Review of the manuscript wes-2025-77, "Wind Tunnel Load Measurements of a Leading-Edge Inflatable Kite Rigid Scale Model" by J.A.W. Poland, J.M. Spronsen, M. Gaunaa, and R. Schmehl.

## Referee #1

## Referee #2

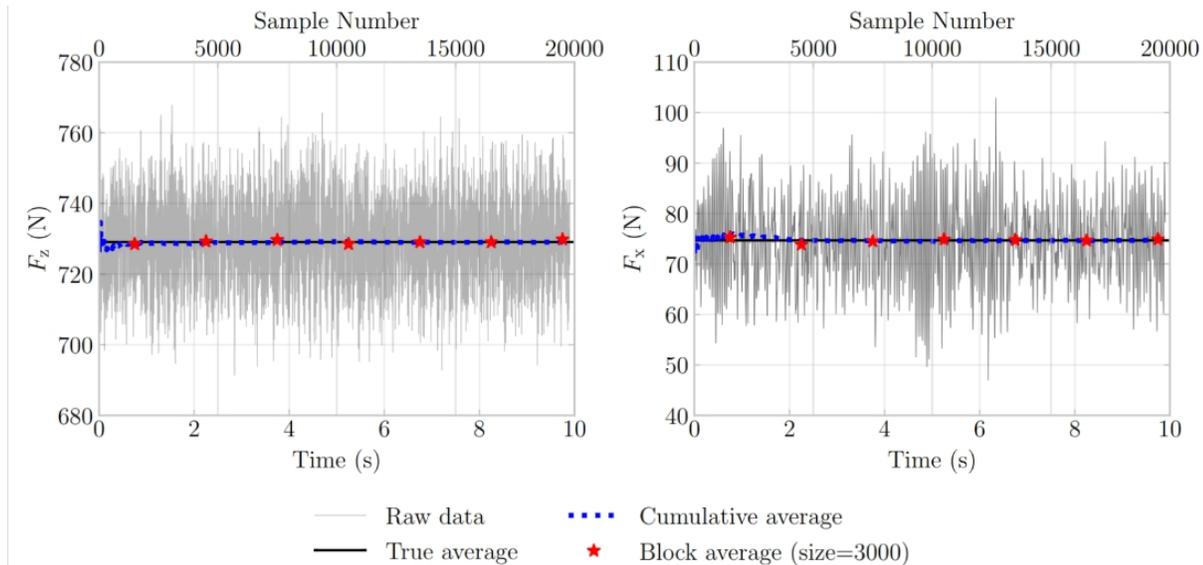
#### **1. Page 8, Line 134: A measurement period of 10 s is used. Is the time sufficient for the convergence of statistics? Discussions on the convergence analysis should be made.**

A 10-second measurement period was selected based on the characteristic aerodynamic time of the system, defined as the time required for a fluid element to traverse the kite's reference chord. For each tested condition, this resulted in 125 to 625 independent flow passages within the 10 s window (depending on the value of the free stream velocity), ensuring that statistical averages are based on many uncorrelated samples rather than being influenced by correlated fluctuations.

To validate statistical convergence, key measurement conditions (e.g.,  $\alpha = 5.7^\circ$  at  $U = 20\text{m/s}$  and  $\beta = -20, 0, 20^\circ$ ) were repeated three times. The close agreement in mean and fluctuating loads between these repeated trials demonstrates that a 10-second interval is sufficient to achieve converged statistics under the present test conditions. For extremely slow or rare dynamic processes, longer sampling periods might be required, but for the steady-state aerodynamic regime investigated here, the chosen duration is well justified.

We also added a figure here, which shows an analysis of a running average and a block analysis. The running average and block analyses show that the fluctuations in the computed statistics over the 10-second window are marginal, confirming that statistical convergence is achieved.

The figure below and subsequent analysis have been added to the manuscript, in Appendix A.
